Section 16 Planning Application for Proposed Temporary Public Vehicle Park (Excluding Container Vehicle) with Ancillary Electric Vehicle Charging Facilities and Utility Installation for Private Project (Solar Photovoltaic System) for a Period of 3 Years at Lot Nos. 1595 (Part), 1597 (Part), 1598, 1599, 1600, 1601 (Part) in D.D. 129 and adjoining Government Land, Lau Fau Shan, Yuen Long, New Territories (Planning Application No. A/YL-LFS/544)

We refer to the latest comments from the Civil Engineering and Development Department (CEDD) and Planning Department and would like to enclose herewith our Responses-to-Comments Table with Further Information to address the abovementioned departmental comments for their consideration.

Table I

Response-to-Comments

Figure 3

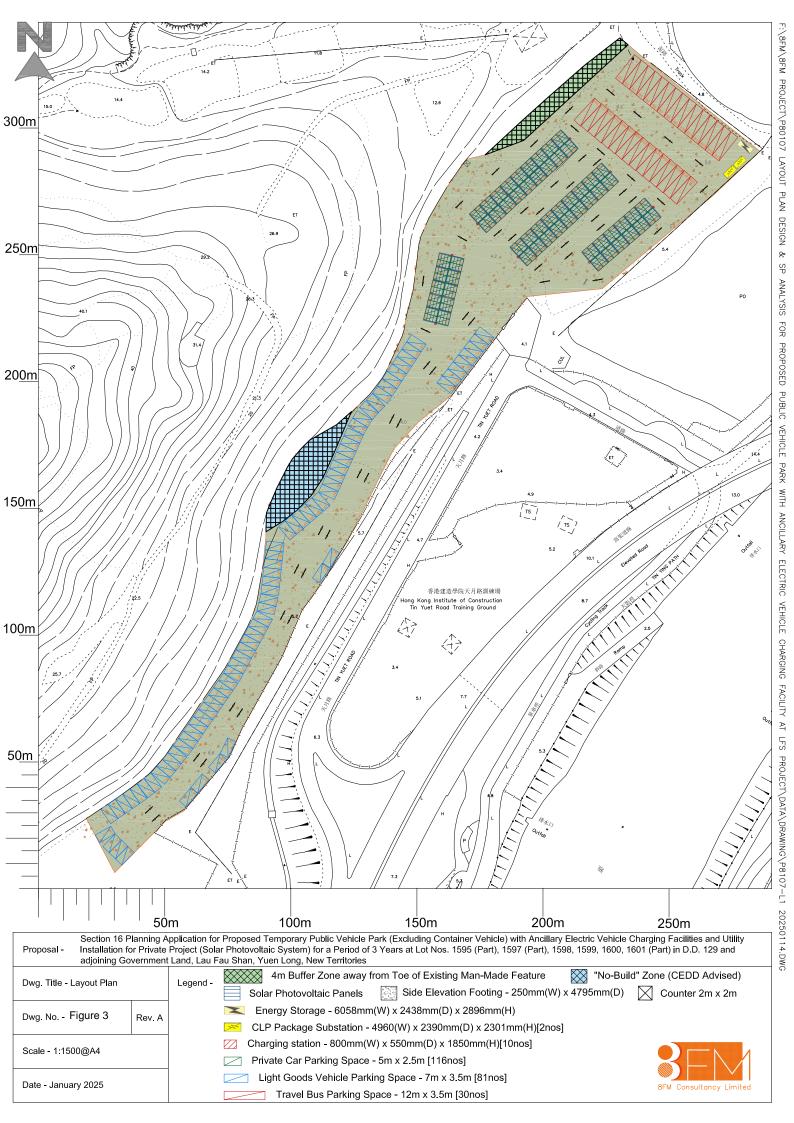
Department	Date	Comments	Responses to Departmental Comments
Geotechnical Engineering Office, Civil Engineering and Development Department	30.12.2024	The proposed development is overlooked by steep natural hillside and meets the alert criteria for a natural terrain hazard study (NTHS). The applicant is required to submit a Geotechnical Planning Review Report (GPRR) in support of the captioned planning application. The GPRR should include a preliminary geotechnical review of the natural terrain hazards, assess the geotechnical feasibility of the proposed development, and where necessary, indicate the recommended extend of the NTHS study area and a commitment to undertake the NTHS and carry out any necessary mitigation measures, as part of the proposed development. Other essential contents of a GPRR are given in the attached GEO advice note.	Noted. Please refer to the response below.
		Given the temporary nature of the proposed use as open carpark of the subject site, the requirement of NTHS might maker the case note economically viable. As an alternative, the north-western part of the subject site may be designated as a 'no build' zone, within which no critical facilities (i.e. facilities under Group 1 to 3 in the attached table) should be located. In particular, the proposed vehicle parking space should be located away from the 'no-build' zone. The suggested extent of the 'no-build' zone is shown in the attached Plan A. With the inclusion of the 'no-build' zone, the requirement for NTHS may be waived.	A 'no build' zone is incorporated into the layout, and the proposed vehicle parking space are located away from the 'no-build' zone (Please refer to revised <b>Figure 3</b> ).
